## REVISED Certificate of Appropriateness Case Report

*Filing Date:* December 2, 2010  
*Case No.:* **2010.1072A**  
*Project Address:* **937 VALENCIA STREET**  
*Historic Landmark:* Liberty-Hill Historic District  
*Zoning:* Valencia Street Neighborhood Commercial District  
50-X Height and Bulk District  
*Block/Lot:* 3609/036  
*Applicant:* Jane Martin  
Shift Design Studio  
2717 Harrison Street  
San Francisco, CA 94110  
*Staff Contact* Richard Sucre - (415) 575-9108  
richard.sucre@sfgov.org  
*Reviewed By* Timothy Frye - (415) 575-6822  
tim.frye@sfgov.org

**DATE:** April 6, 2011  
**TO:** Architectural Review Committee of the Historic Preservation Commission  
**FROM:** Rich Sucre, Historic Preservation Technical Specialist, (415) 575-9108  
**RE:** **Review and Comment for 937 Valencia Street**  
**Case No. 2010.1072A**

PROPOSED PLAN

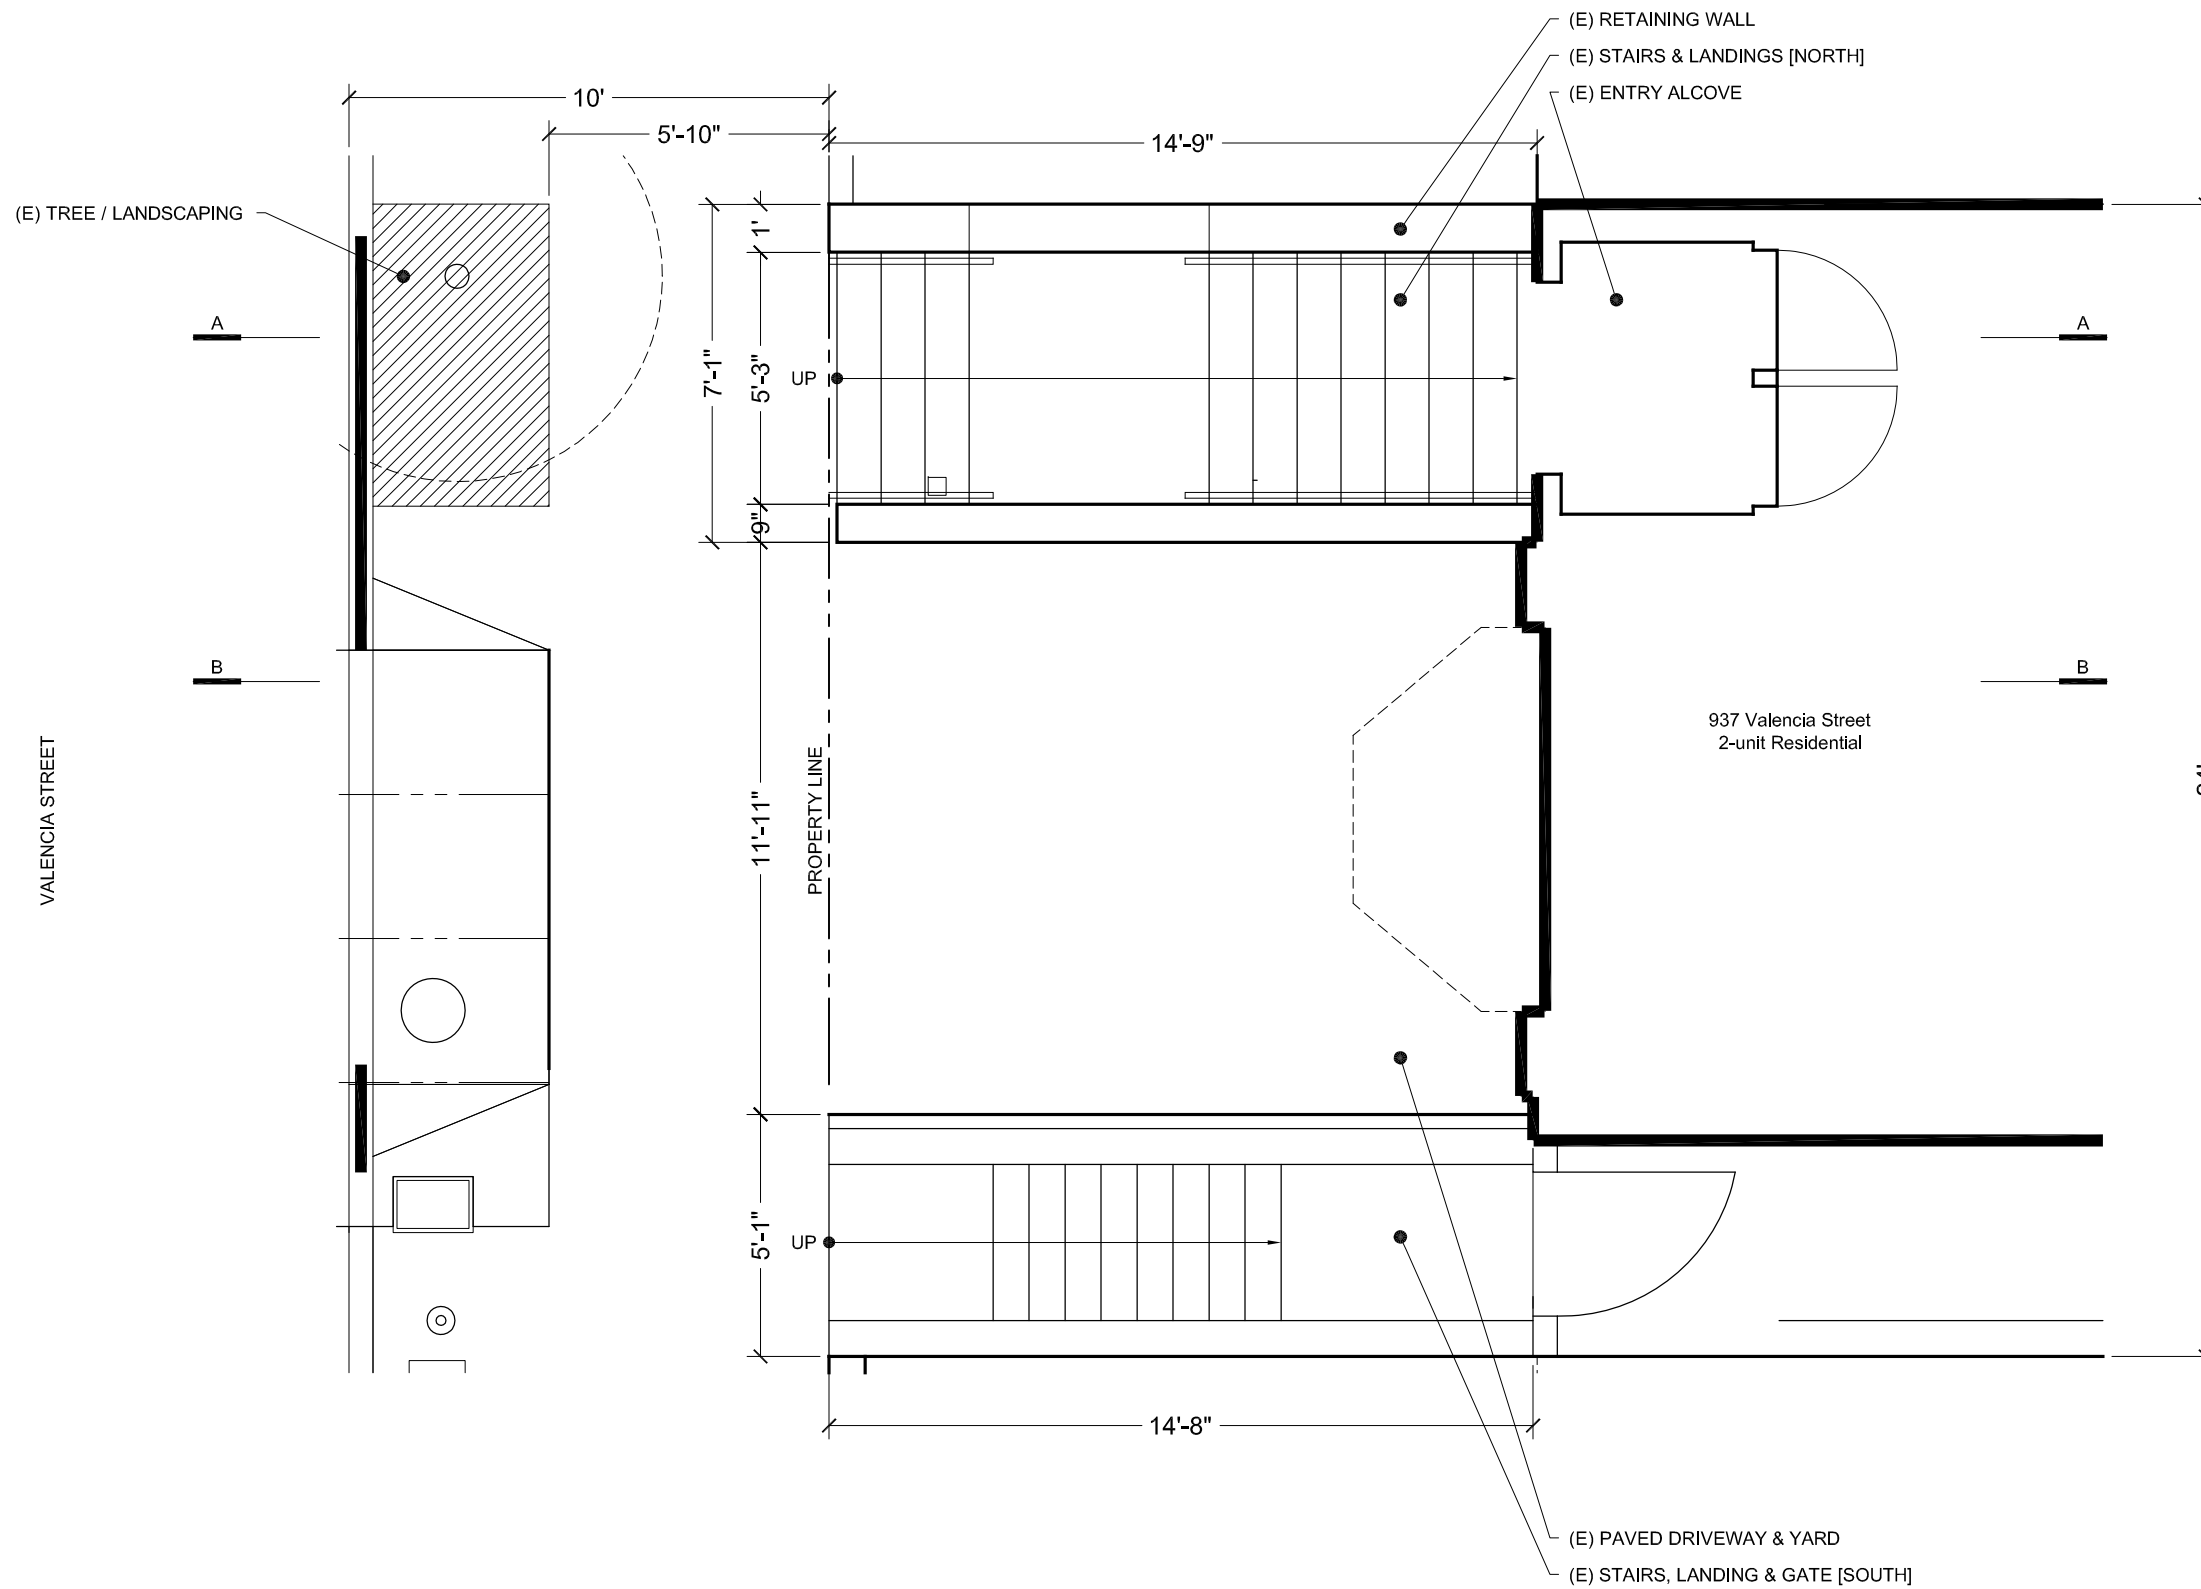
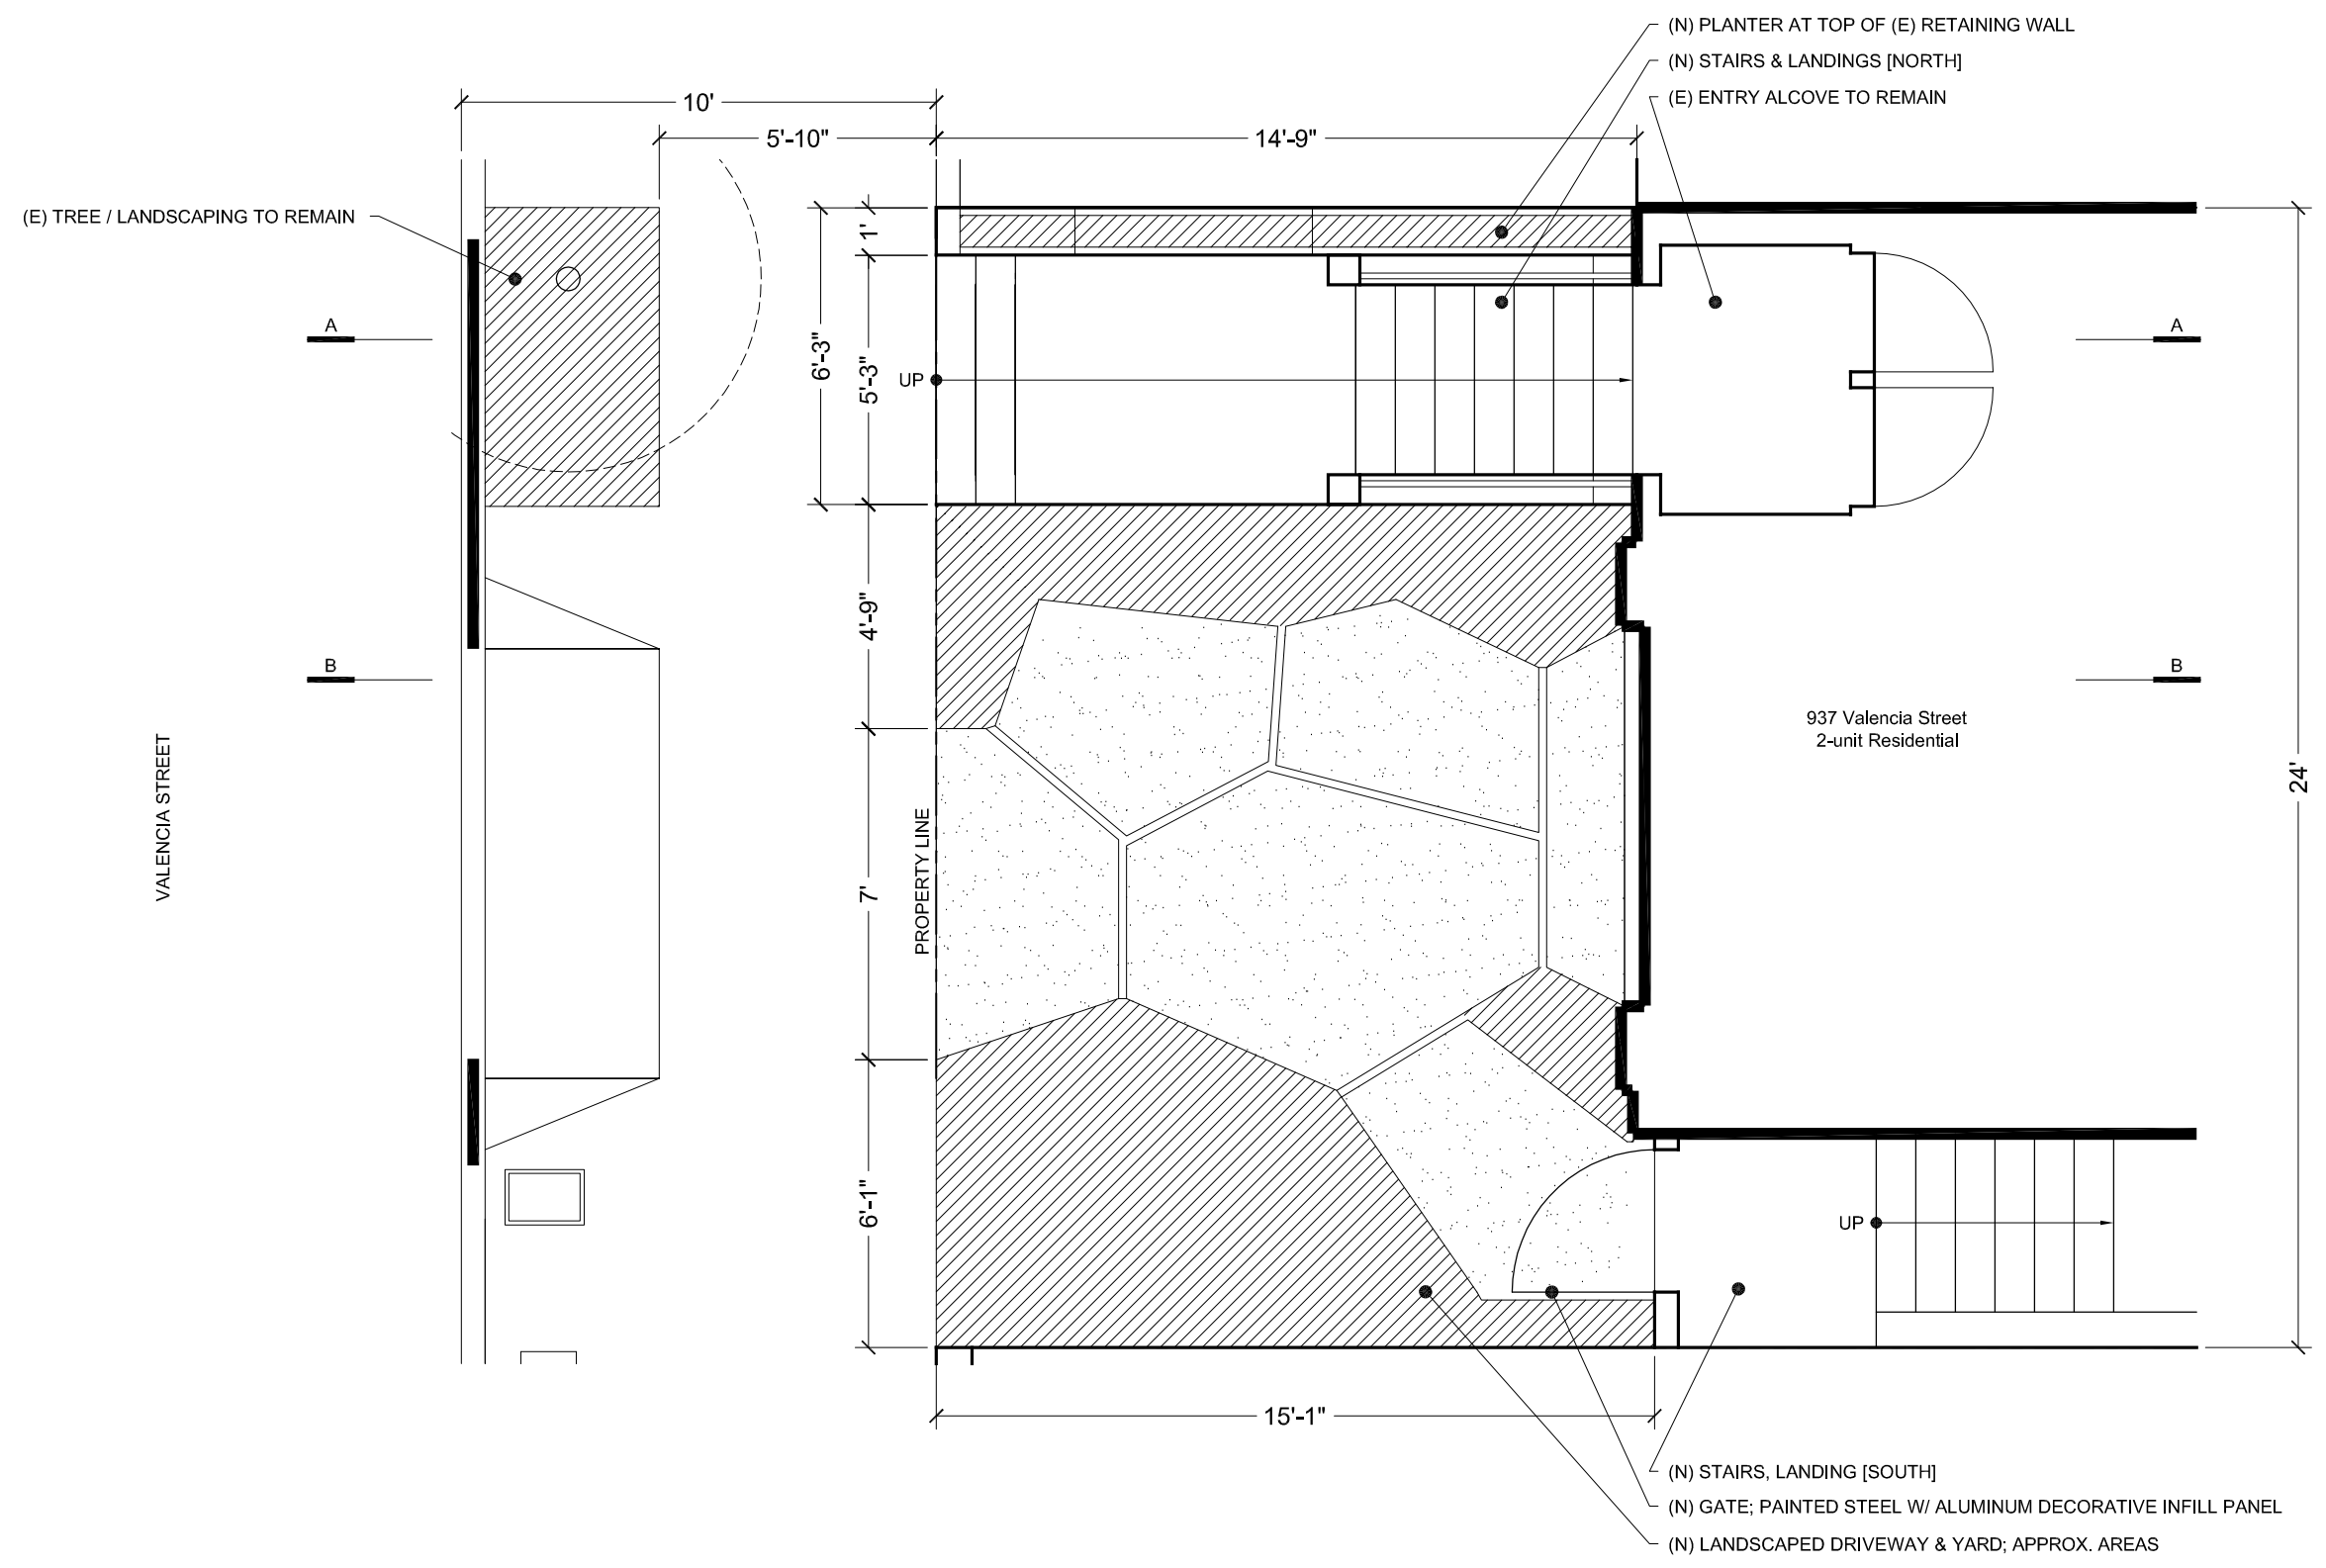
**Removal/Reconfiguration of Main Entry Staircase:** The existing main entry staircase is not historic, and is not defined as a character-defining feature of the historic district. This existing staircase is a later alteration to the subject property and is of a similar character to other staircases found in the district. The adjacent historic staircases have concrete construction at the base and vary in tread/riser materials from concrete to terrazzo to wood. Likely, the historic staircases would have been constructed of wood, and would have featured wood or metal handrails with prominent newel posts and vertical wood members, often turned elements. The proposed project will remove and reconfigure the existing concrete and terrazzo main entry stair with a concrete and wood straight-run stair. This new stair will feature a concrete base. In addition, the new staircase will feature new steel handrails with decorative metalwork and a painted finish. The removal/reconfiguration of the main entry staircase will not adversely affect the building or the surrounding historic district. The material character and design of the new staircase is in keeping with the adjacent properties. Like the historic staircases, the new staircase is also a straight run stair with wood treads and risers. The design of the new staircase is differentiated from the existing historic fabric, and is relatively simple in design, thus it will not compete the overall reading of the building's historic fabric.

The Project Sponsor has incorporated two concrete newel posts into the design of the new staircase, thus fulfilling an earlier staff recommendation. A newel post or a heavier, vertical element is common among the metal and wood handrails found within the historic district (For examples, please refer to the attachments). Typically, the newel post occurs in pairs on either side of a stair at the base of on the ground floor level or on an intermediary landing. The two newel posts are located on the landing at the base of the upper stair, and are consistent with examples found in the historic district.

PROPOSED B-B

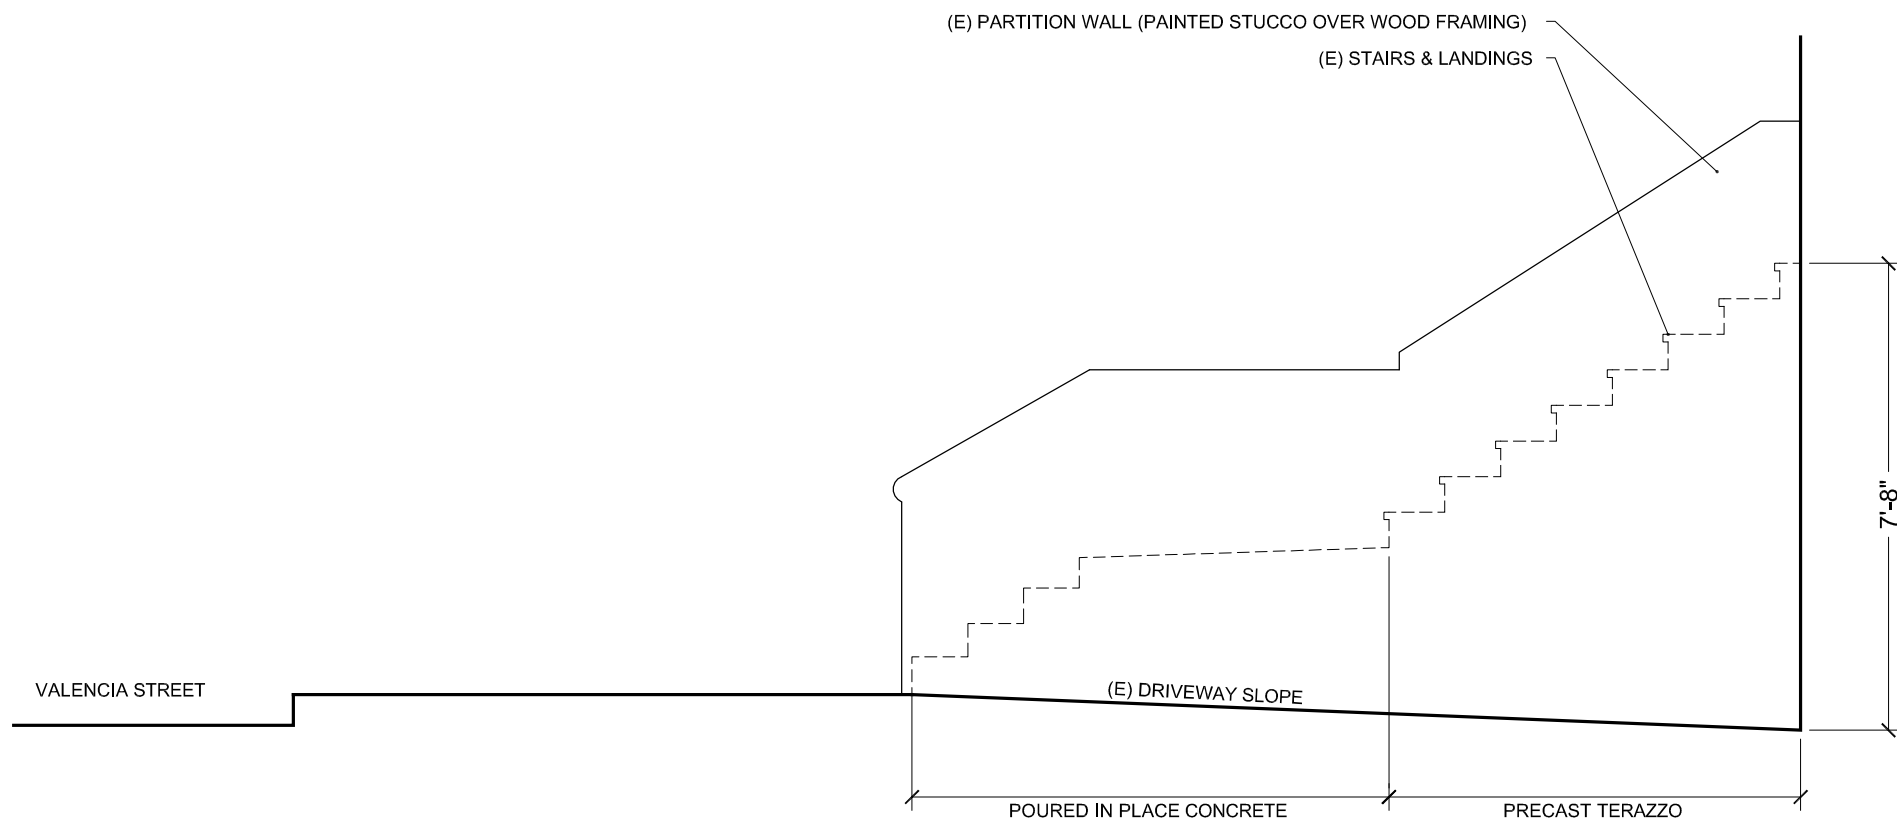
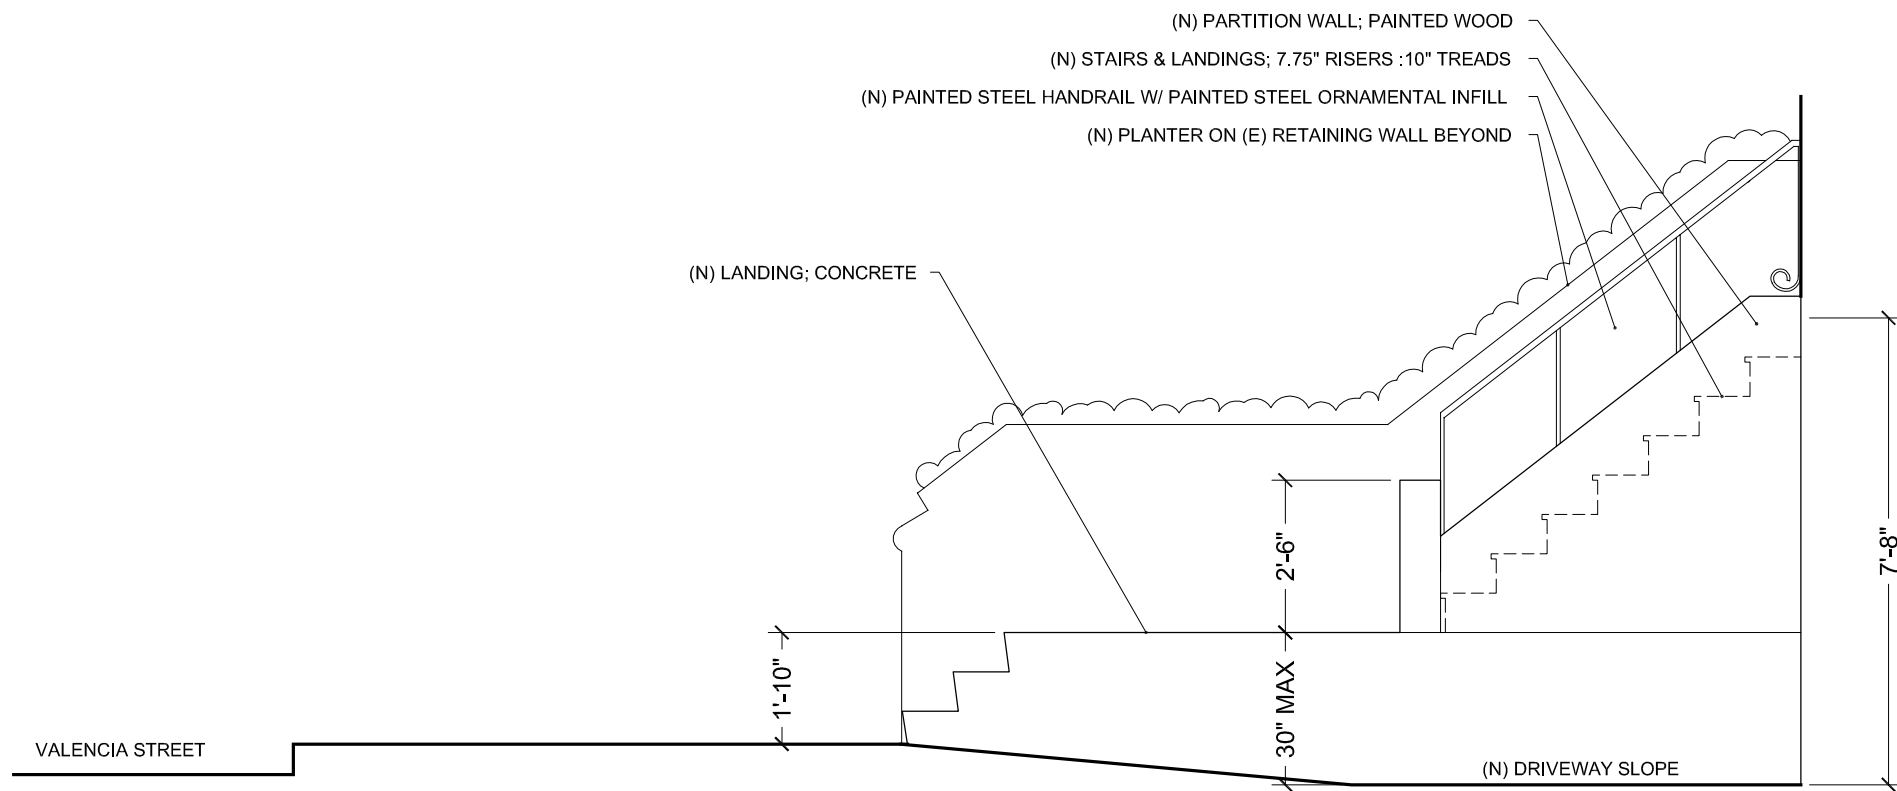
The historic staircase was removed and replaced prior to landmark designation. The proposed project will remove and reconfigure the existing, non-historic, concrete and terrazzo main entry stair with a concrete and wood straight-run stair. This new stair will feature a concrete base and a narrow landing shelf that will extend approximately two feet into the front yard.

The HPC determined that the landing shelf is not compatible with the character of the historic district, and seems out of scale with the front yard.

The Department finds the variant to be much improved compared to the proposed project, since it addresses the concerns regarding the landing shelf and the appearance of the stair relative to the front yard. The Department recommends adopting the variant.
